APPLICATION FOR A BUILDING ADDITION, BUILDING CONVERSION, RENOVATION OR ACCESSORY STRUCTURE

Property Address: 12 HEDLEY FARMS ROAD

| SITE IMPROVEMENTS PLAN FOR THE PROPOSED PATIOS, BARBECUE AND DRIVE ALTERATIONS                       | SCALE<br>AS NOTED    |
| <b>SITE PLAN, DETAILS &amp; NOTES</b>  | PROJECT NO.<br>30216 |

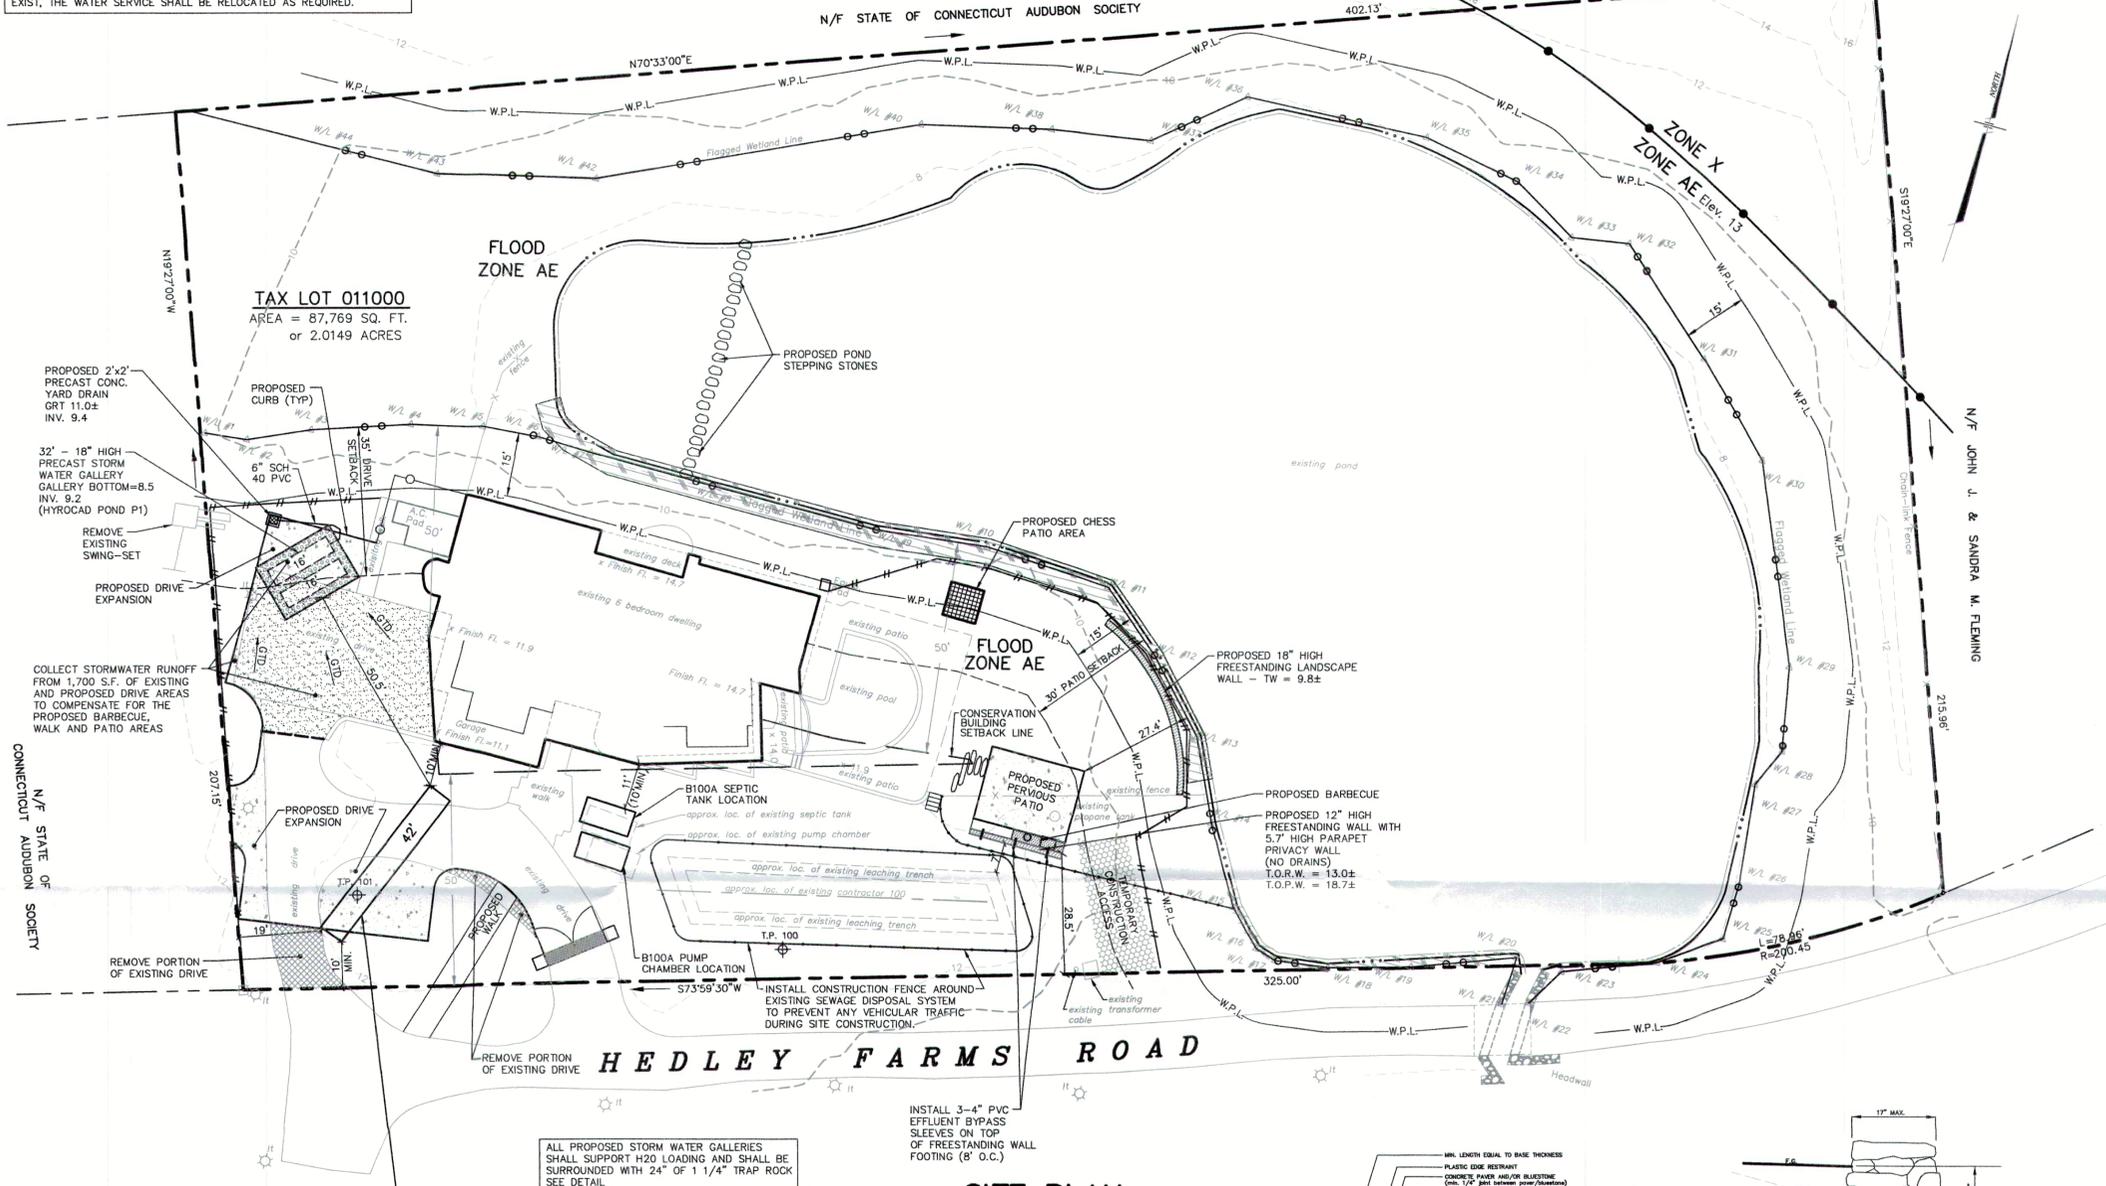
Comments: BBA to have no sink Blown on full wall has no drains
